Limerick Generating Station, Units 1 and 2
Renewed Facility Operating License Nos. NPF-39 and NPF-85
NRC Docket Nos. 50-352 and 50-353

SUBJECT: License Amendment Request
Proposed Change to Add New Limiting Conditions for Operation 3.0.5 and
3.0.6

License Amendment Request

Limerick Generating Station, Units 1 and 2

Figure B 3.0-1
Configuration of Trains and Systems

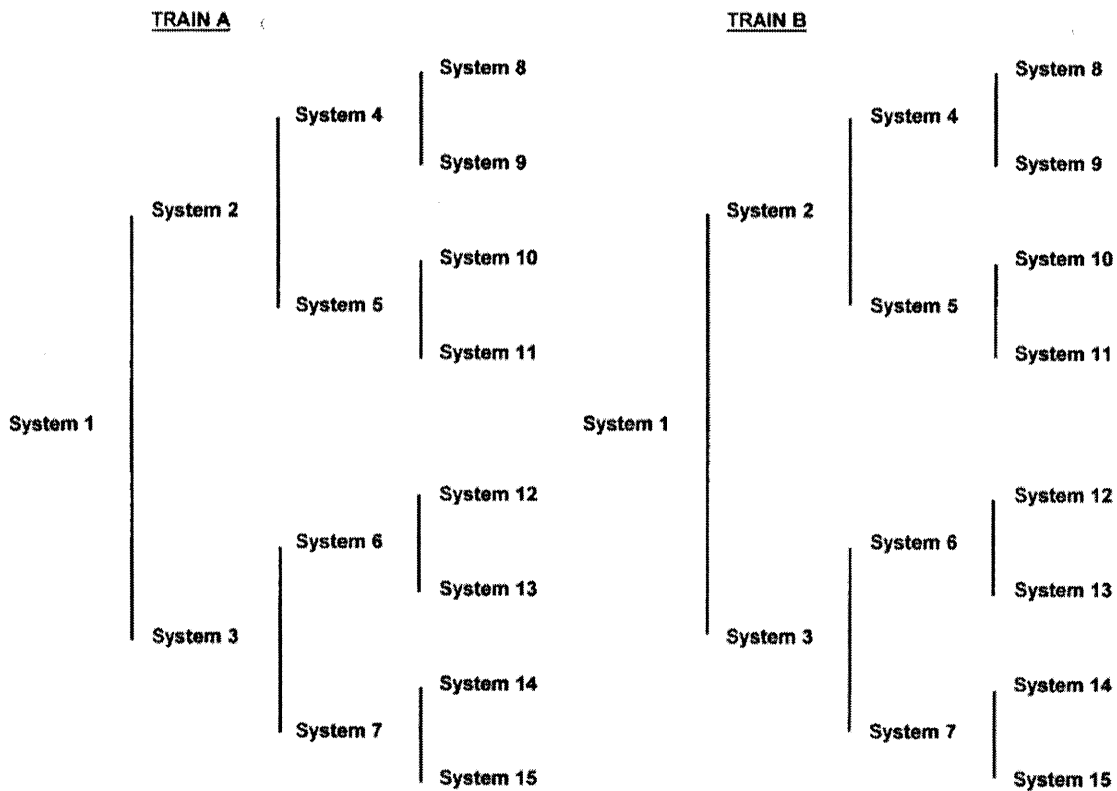
The following examples use Figure B 3.0-1 to illustrate loss of safety function conditions that may result when a TS support system is inoperable. In this figure, the fifteen systems that comprise Train A are independent and redundant to the fifteen systems that comprise Train B. To correctly use the figure to illustrate the SFDP provisions for a cross train check, the figure establishes a relationship between support and supported systems as follows: the figure shows System 1 as a support system for System 2 and System 3; System 2 as a support system for System 4 and System 5; and System 4 as a support system for System 8 and System 9. Specifically, a loss of safety function may exist when a support system is inoperable and:

For the following examples, refer to Figure B 3.0-1.

EXAMPLE B 3.0.6-3

If System 2 of Train A is inoperable, and System 1 of Train B is inoperable, a loss of safety function exists in Systems 2, 4, 5, 8, 9, 10 and 11.

Figure B 3.0-1
Configuration of Trains and Systems

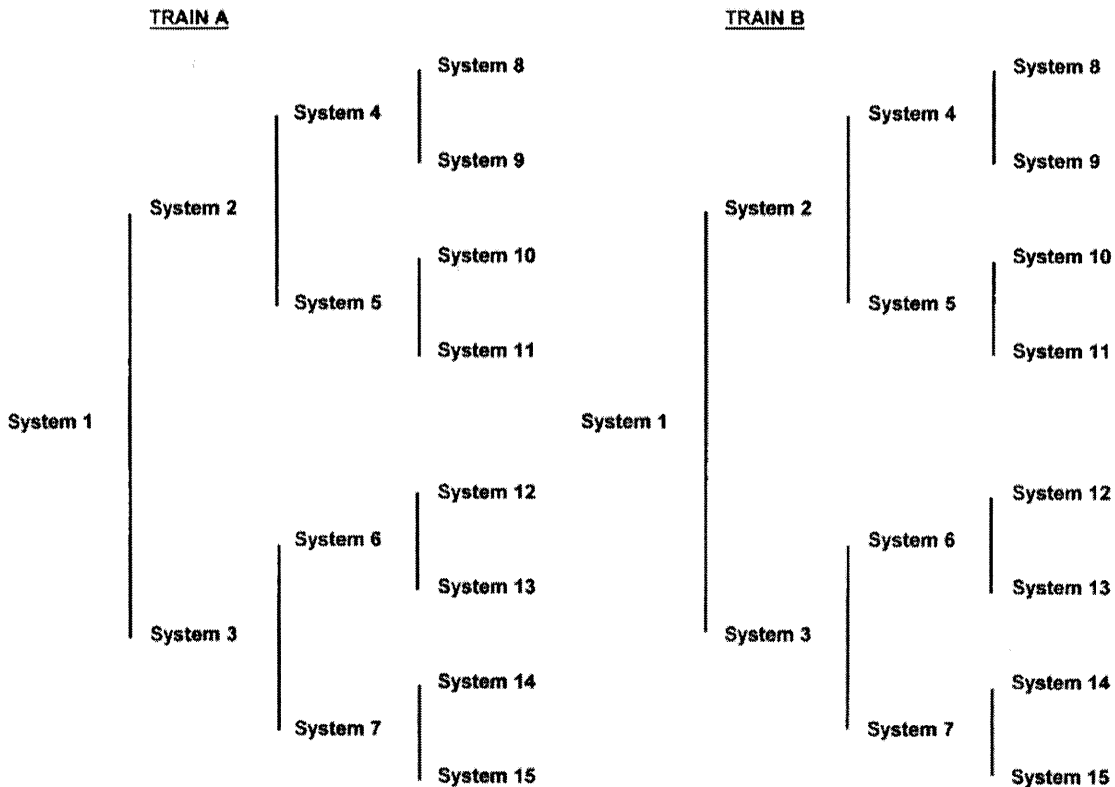
The following examples use Figure B 3.0-1 to illustrate loss of safety function conditions that may result when a TS support system is inoperable. In this figure, the fifteen systems that comprise Train A are independent and redundant to the fifteen systems that comprise Train B. To correctly use the figure to illustrate the SFDP provisions for a cross train check, the figure establishes a relationship between support and supported systems as follows: the figure shows System 1 as a support system for System 2 and System 3; System 2 as a support system for System 4 and System 5; and System 4 as a support system for System 8 and System 9. Specifically, a loss of safety function may exist when a support system is inoperable and:

For the following examples, refer to Figure B 3.0-1.

EXAMPLE B 3.0.6-3

If System 2 of Train A is inoperable, and System 1 of Train B is inoperable, a loss of safety function exists in Systems 2, 4, 5, 8, 9, 10 and 11.
